MANDATORY SERVICE BULLETIN

NO. MSB-D4-056

Coolant Tank Cap – Pressure Relieve Test

WI-MSB-D4-056

3. Unplug the breather line and install a clear hose. Fill clear hose partly with coolant liquid or water.

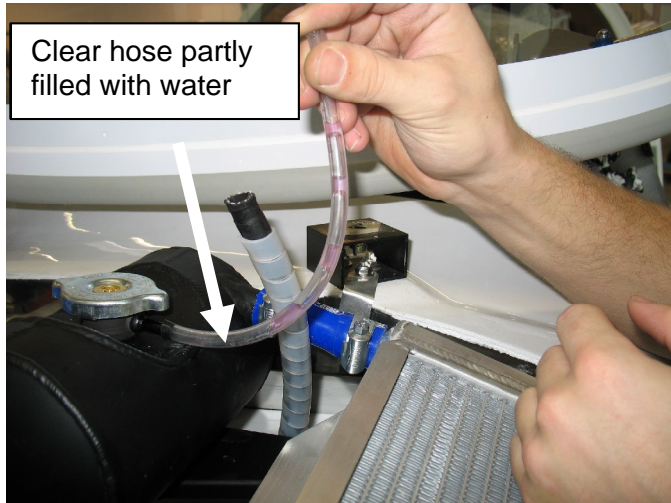
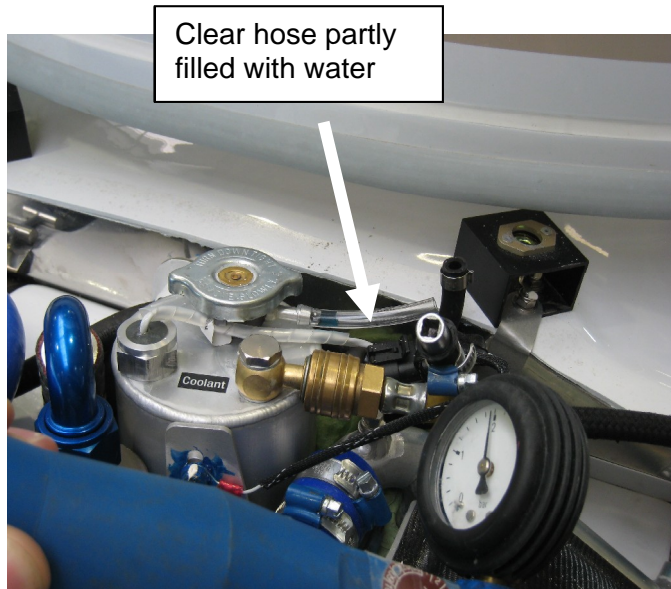
4. Put on the coolant tank cap and pressurize up to release pressure of the cap. Rising bubbles in the clear hose indicate pressure relieve.

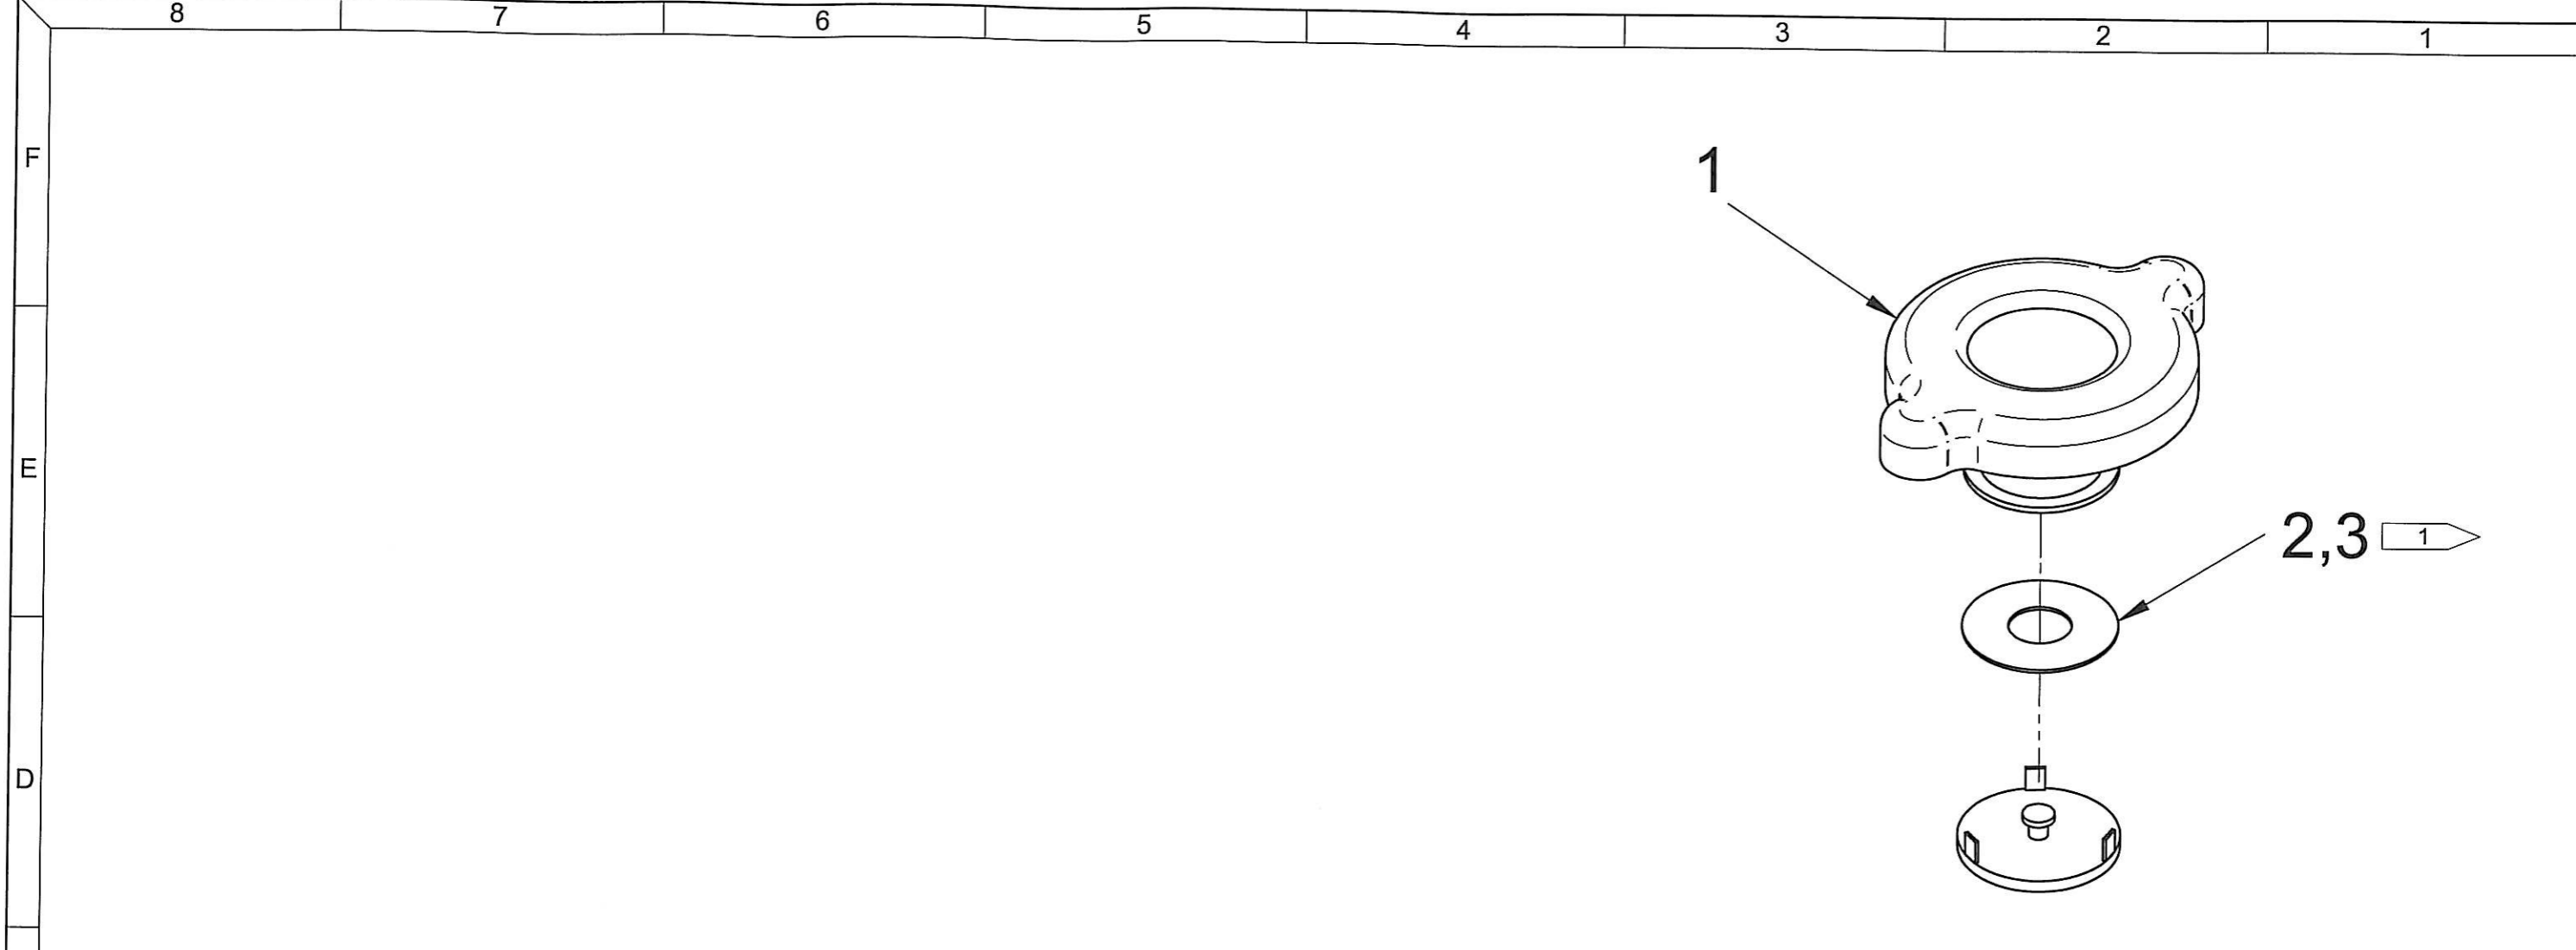
Shim washers item 2 or item 3 or any combination as required to achieve a relieve pressure of 1,8 to 2,3 bar (26.1 psi to 33.3 psi) at both cap positions.

<p>6.</p>	<p>For both orientations of the cap, the cap's relieve pressure must be within following limits:</p> <p>Minimum relieve pressure: 1,8 bar (26.1 psi) Maximum relieve pressure: 2,3 bar (33.3 psi)</p> <p>CAUTION: The pressure must not exceed 2,7 bar (39.1 psi) at any time of testing.</p>
<p>7.</p>	<p>If the cap's relieve pressure does not meet the requirements the cap needs to be modified in accordance with drawing D60-7526-30-29.</p> <p>Redo the test procedure (items 4 and 5); add 1 washer each time until the requirements are met for both cap positions.</p> <p>NOTE: Before doing the pressure testing check the modified cap for proper fit. The sealing plane of the cap must be even and parallel to the tank's sealing plane.</p> <p>NOTE: It is just necessary to bend one of the 3 latches to remove the lower portion of the cap.</p> <p>NOTE: Experience has shown that each latch can be bended (up and back again) 3 to 4 times. It is advised to alter the latches during the adjustment process.</p> <p>CAUTION: The bent latches must be inspected for cracks and proper fit before the cap gets released to service.</p> <p>NOTE: If the required relieve pressure is not achievable with by modifying the cap a new cap must be used.</p>
